TAMC Board Meeting 3-25-26

Agenda Item #7, State Route 68 Status Report

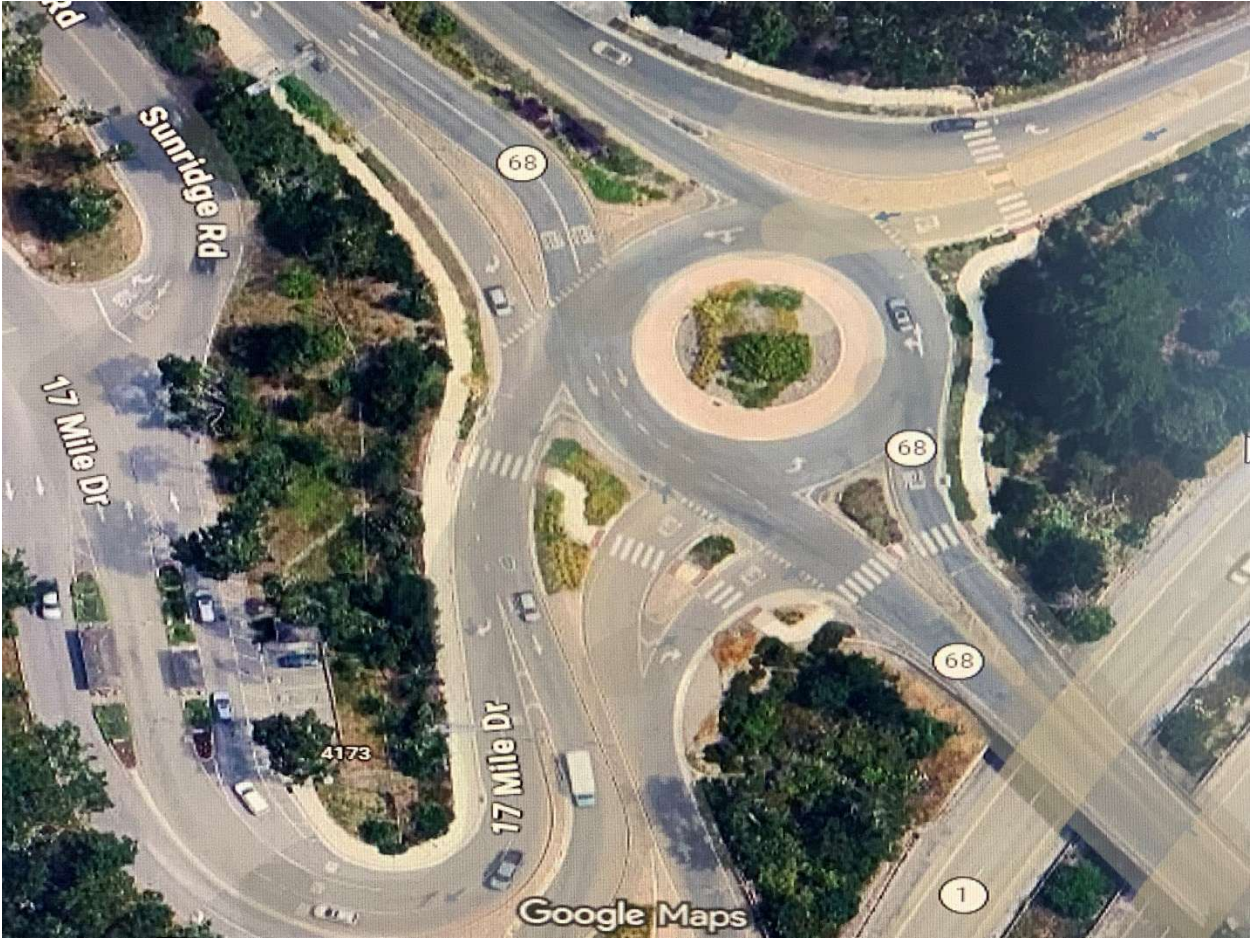
As mentioned earlier the report total is \$69 Million versus the Budget total of \$126 Million for Phase 1 so why the difference? Does the \$69M include land acquisition and other costs and **what are the projected cost for construction that will be done in 2028 or beyond? Will it continue escalating at the same significant percentage?** What part of the \$69M is for the 2 Wildlife Crossings? The Caltrans estimated costs done in December 2023 had the current costs at \$626,400 for the San Benancio crossing and \$1,467,600 for the Laureles Grade crossing.

Modified 2 Lane "Hybrid" Roundabout at Corral de Tierra Rd

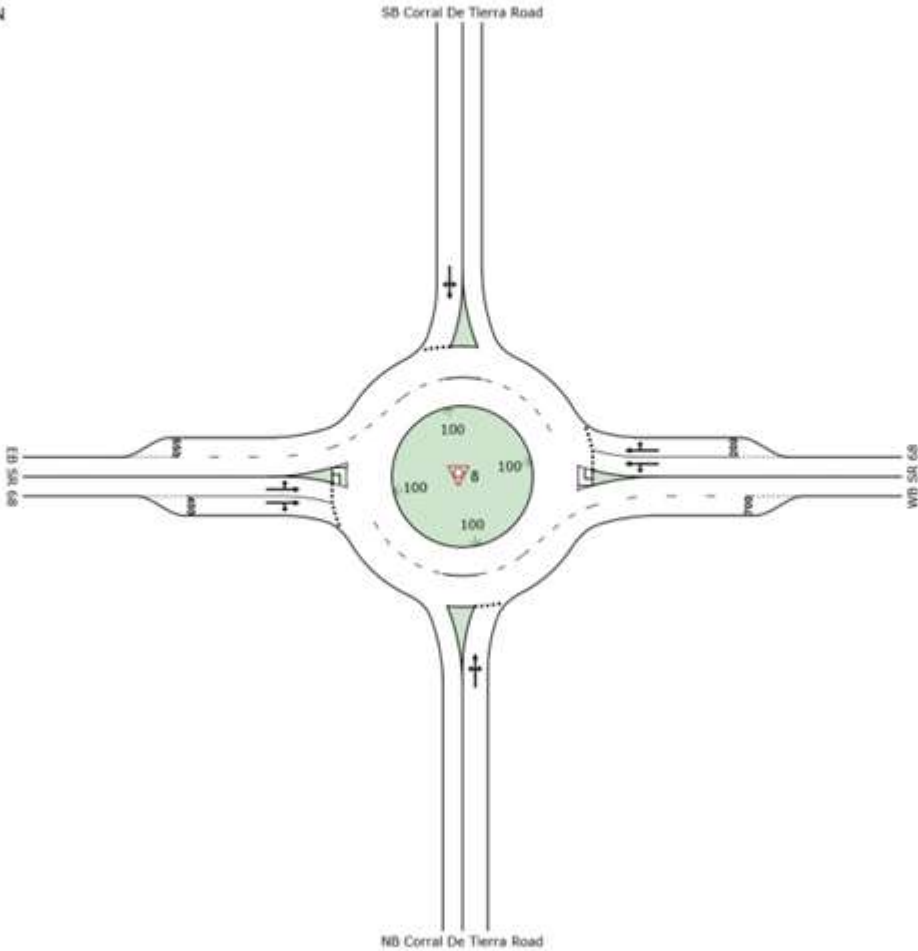
The comparison that Doug makes in his report that the Phase 1 “hybrid” roundabouts are “similar” to the Holman/Pebble Beach roundabout is **misleading and not accurate**. The Pebble Beach roundabout produced congestion reduction due to its truly “hybrid” design where all of the **traffic from Hwy 1 south to Holman does not even go through the roundabout as well as the Holman traffic traveling east to Pebble Beach, which also does not go into the roundabout**. Plus, all of the lanes are single except for a short section of 2 lanes and the traffic pattern is different than Hwy 68. Unlike Pebble Beach, **all of the traffic traveling on Hwy 68 must go into the 2 lane roundabout and then yield to each other as they merge back into the single lane on the other side**. This merging also increases the conflict points and chance of more crashes as vehicles try to merge back together with the aggressive drivers taking advantage of the passing opportunity. It seems the main reason to call Phase 1 roundabouts “hybrid” is to try to make people believe, without showing the details, that they would operate in a similar way as Pebble Beach, which is **not accurate**.
